Docket Item # 10  
BAR CASE # 2008-0184

BAR Meeting  
November 5, 2008

**ISSUE:** Alterations  
**APPLICANT:** Jamie Lynch  
**LOCATION:** 612 Queen Street  
**ZONE:** OCM(50)

The applicant is requesting approval of a Certificate of Appropriateness for replacement windows at 612 Queen Street.

Figure 1: Photograph indicating proposed windows to be replaced.

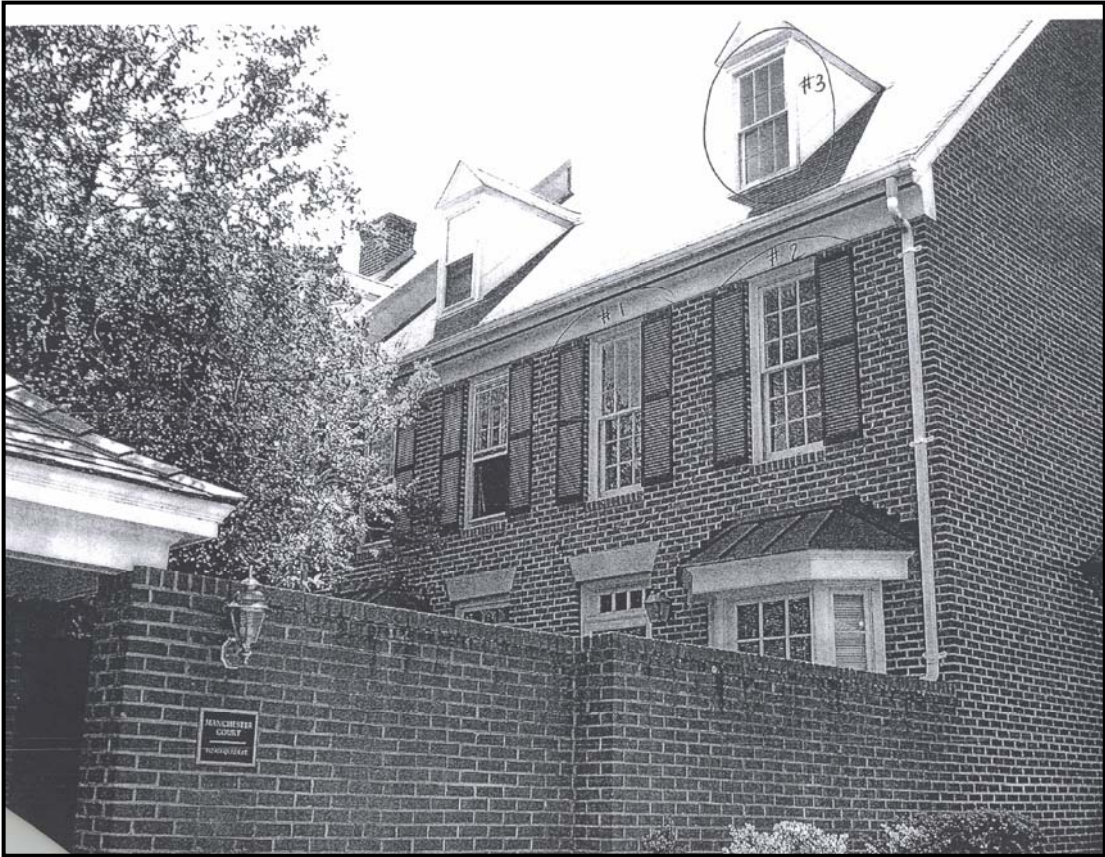
The applicant is proposing replacement of three existing wood, double-hung, six-over-six, single glazed windows with double-hung, double glazed, simulated divided light with interior spacer bar, six-over-six, aluminum windows manufactured by Pella.

With this in mind, Staff cannot support the proposed use of aluminum windows as replacement since aluminum windows are clearly not recommended for replacement in the local historic districts (*Design Guidelines*, Windows -page 2). The Board has consistently upheld this guideline. Staff would support window replacement with the condition that the replacement windows are wood, double-hung, either single or double glazed, true divided or simulated divided light with spacer bar, and in a six-over-six configuration.

F-1 If any of the existing windows are fire-rated, then the proposed window is required to be fire rated.

R – Deny

S – Approve, subject to substitution of wood double hung windows rather than aluminum cladding.

1. That the replacement windows be wood, double-hung, either single or double glazed, and true or simulated divided light in a six-over-six configuration.
